This Service Information bulletin supersedes SI 17 05 12 **dated October 2012.**

Service Action: Retrofit of the Engine Coolant Temperature Sensor

R60 with automatic transmission (N16 or N18 engine)

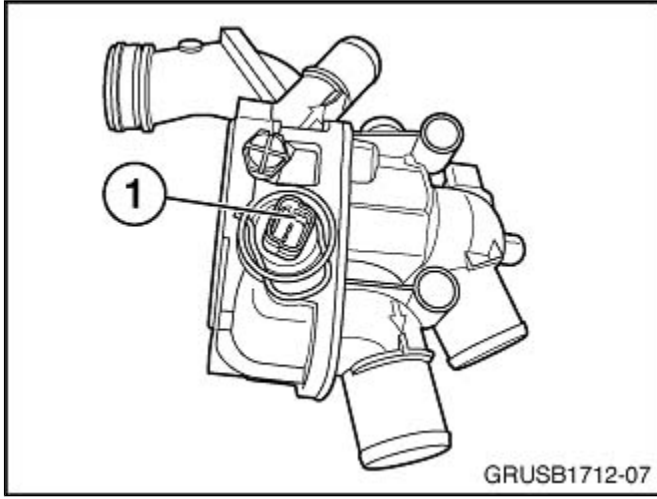
NEW There are two approved repair procedures, depending on parts availability. Both procedures involve installing an engine temperature sensor remotely and wiring this new sensor into the vehicle's engine harness. Only perform one of these recommended procedures when completing this Service Action.

NEW **Procedure One** requires the replacement of the upper coolant hose with a modified hose that houses a new engine temperature sensor. An adapter harness needs to be fitted to the car to utilize this new sensor.

NEW **Procedure Two** requires the installation of a new engine temperature sensor, with integrated wire harness, installed in place of the thermostat bleeder screw.

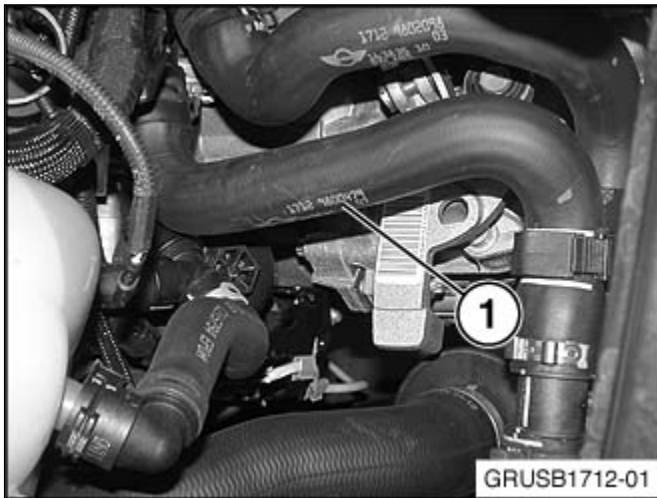
NEW **Note: This Service Action does not apply to any N16 engine that had a thermostat replaced with P/N 11 53 7 534 521.** Vehicles equipped with the N16 engine may have had repairs performed prior to this Service Action, so installing this remote sensor and hose or the sensor in place of the bleeder screw is no longer required.

Checking for the updated thermostat:
The 11 53 7 534 521 thermostat has a replaceable engine temperature sensor (1).

- Replace the engine wiring harness with the 11 53 7 534 521 thermostat.
- Do not install the remote engine temperature sensor. Claim the labor operation “Check for 11 53 7 534 521 thermostat installation” in the Warranty Information section of this bulletin.
- Affix the Service Action label to the B-pillar.

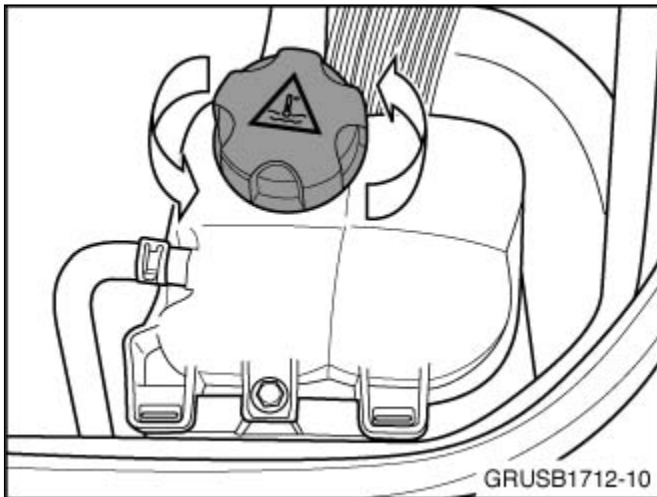
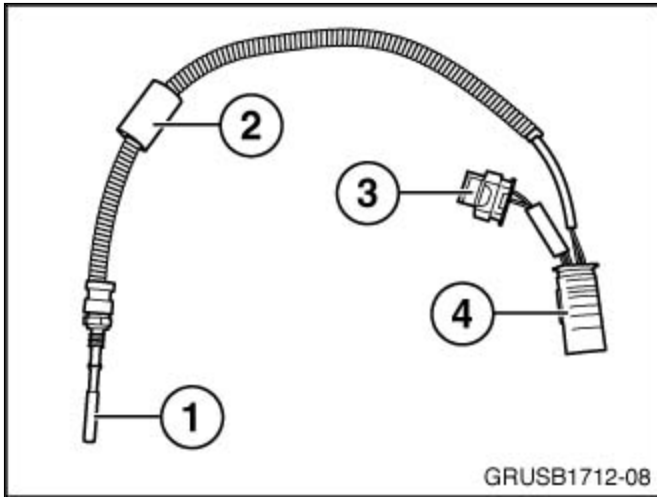
The improved sensor (P/N 13 62 8 603 908) includes the temperature probe (1) and insulating sleeve (2), a two-pin female connector (3) for the map thermostat, and a four-pin connector (4) for the engine harness.

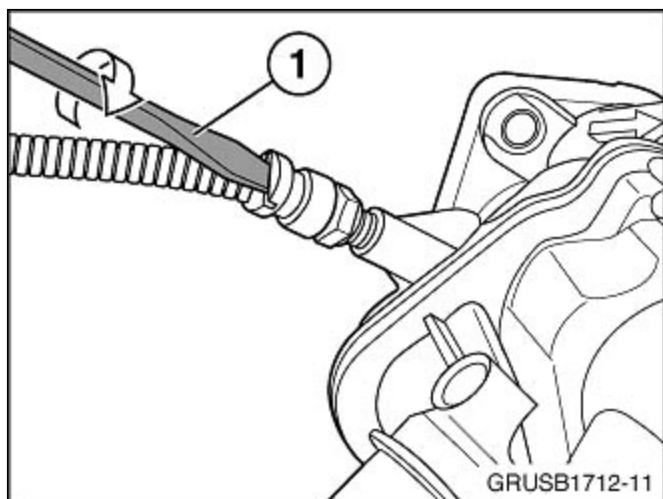
Remove the bleeder screw (1) from the thermostat. This screw will not be reused.

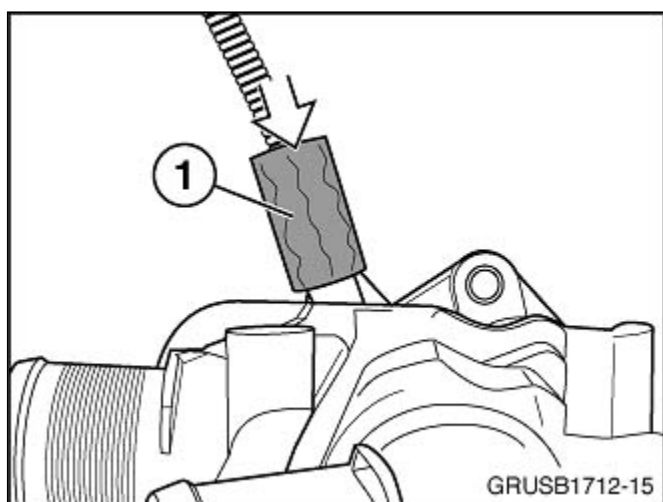
The back of the temperature sensor is slotted to accept a bladed screwdriver (1). Install the sensor into the bleeder screw hole, and torque to 2Nm.

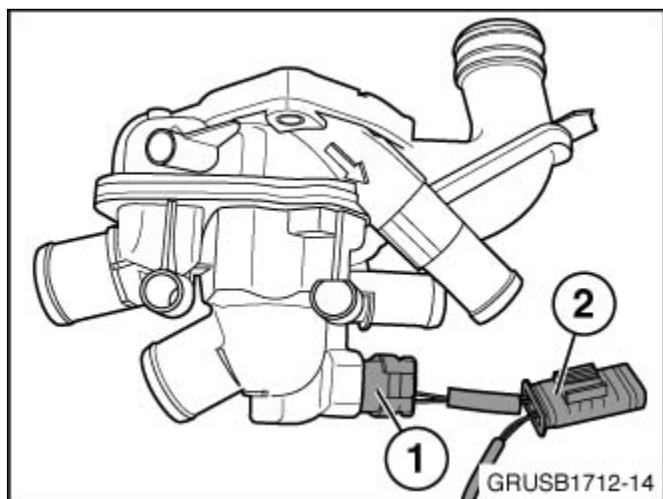
Slide insulating sleeve (1) onto the temperature sensor. The sleeve must completely cover the sensor.

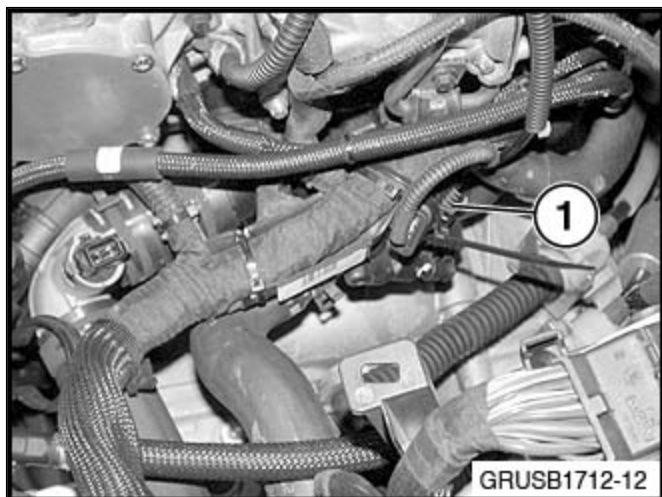
Install the two-pin female connector (1) into the thermostat and the four-pin male connector (2) into the engine wiring harness.

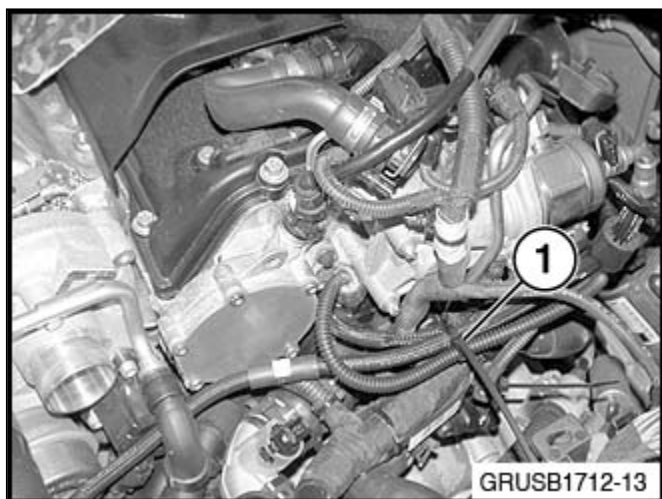
Secure the connector (1) with a cable tie to the engine wiring harness.

Secure the wiring from the temperature sensor (1) with a cable tie.
